D350-748-203
Job Sheet 164646

Part Name: AS350 / AS355 Stainless Steel Aft Crosstube

DRAWING NO. D350-748-243	TITLE CROSSTUBE	REV. A	DART AEROSPACE LTD ENGINEERING ORDER		D.E.O. NO. D350-748-243-A-1	SHEET NO. SHEET 1 OF 1	SCALE NTS
DRAWN <i>qp</i>	CHECKED <i>ASS</i>	MFG. APPR. <i>[Signature]</i>	APPROVED <i>[Signature]</i>		DE APPR. <i>[Signature]</i>		
DATE 15.11.18	DATE 15.11.18	DATE 16.02.19	DATE FEB 19 2016		DATE 2016.02.19

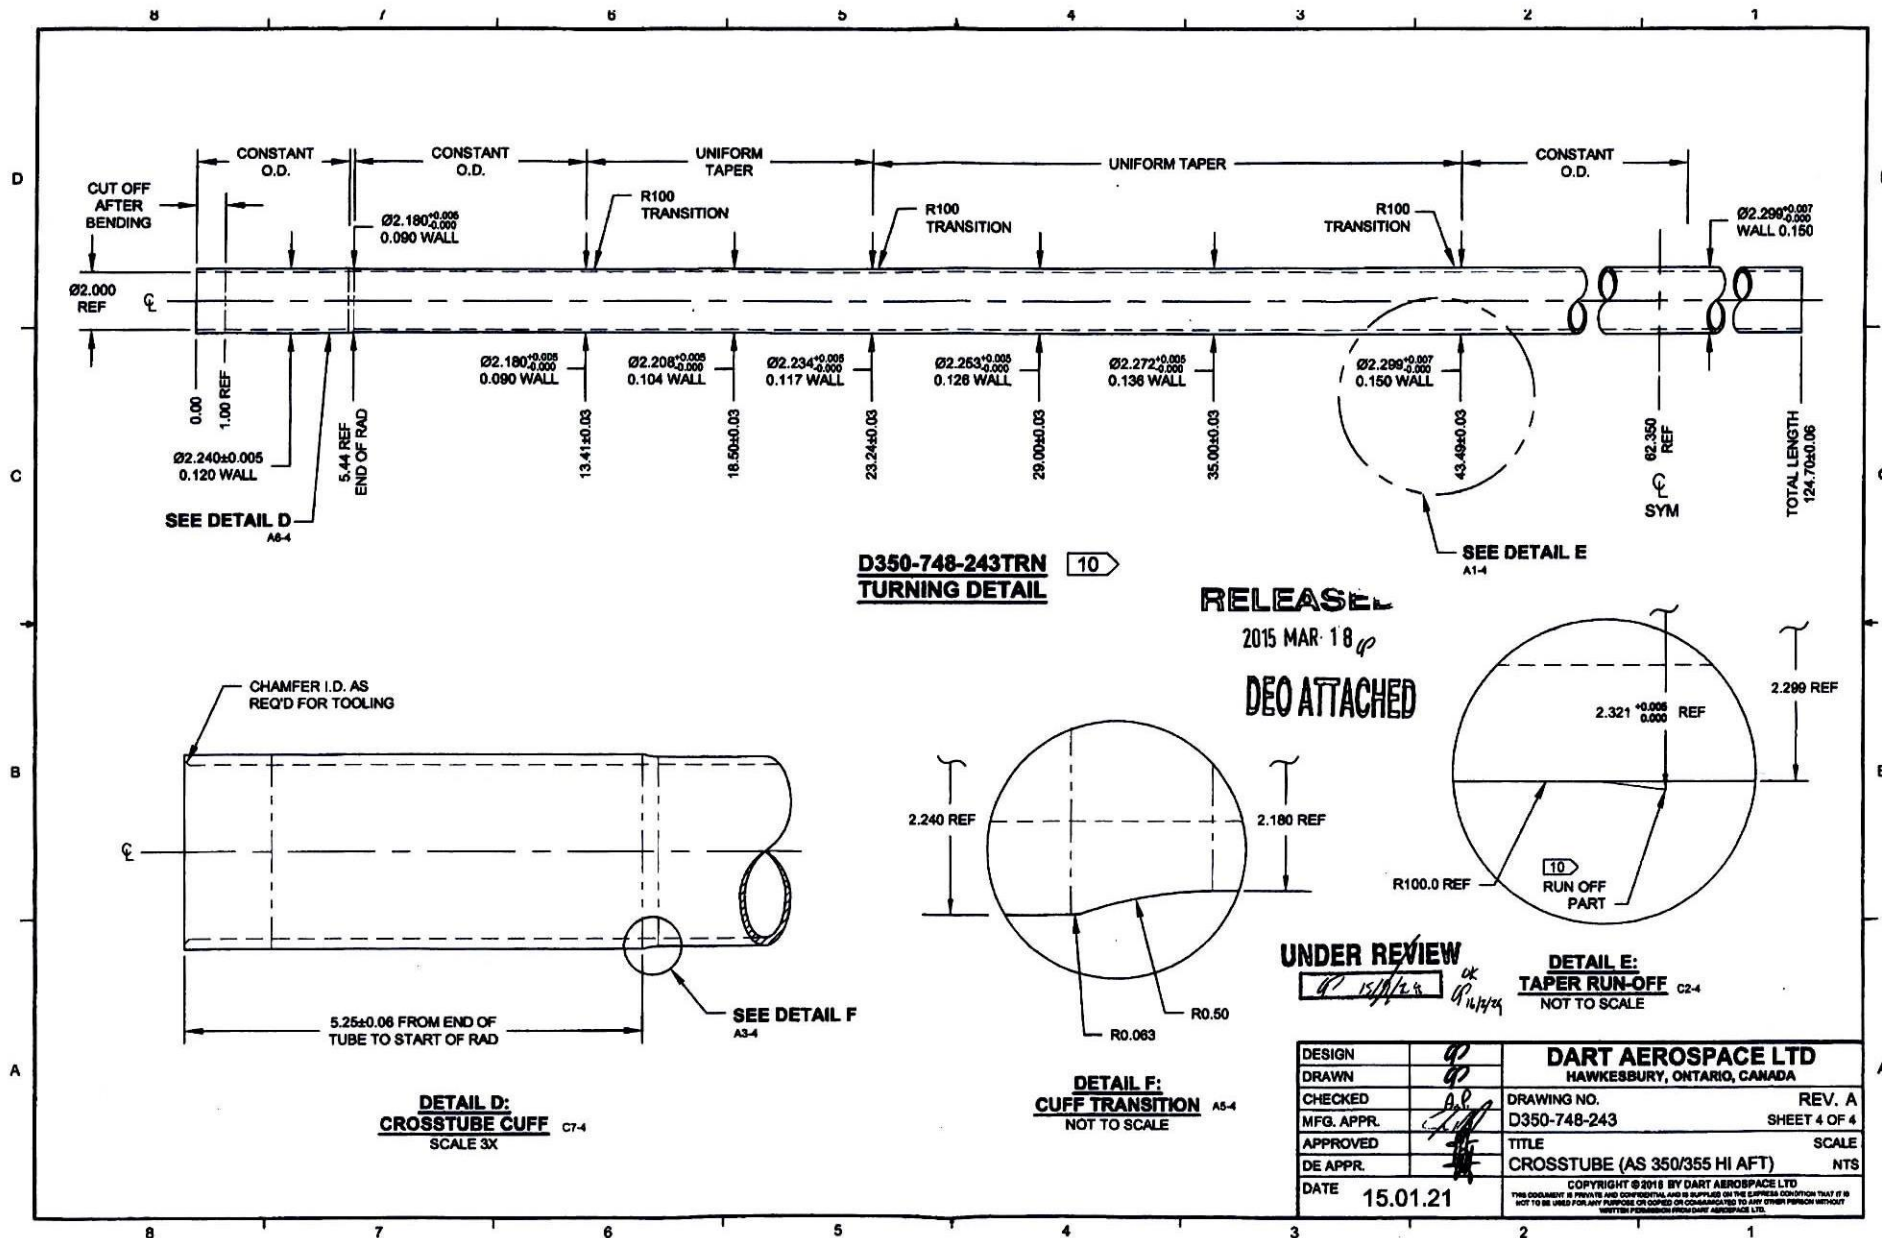
AMEND NOTE 2 (SHEET 1) AS FOLLOWS:
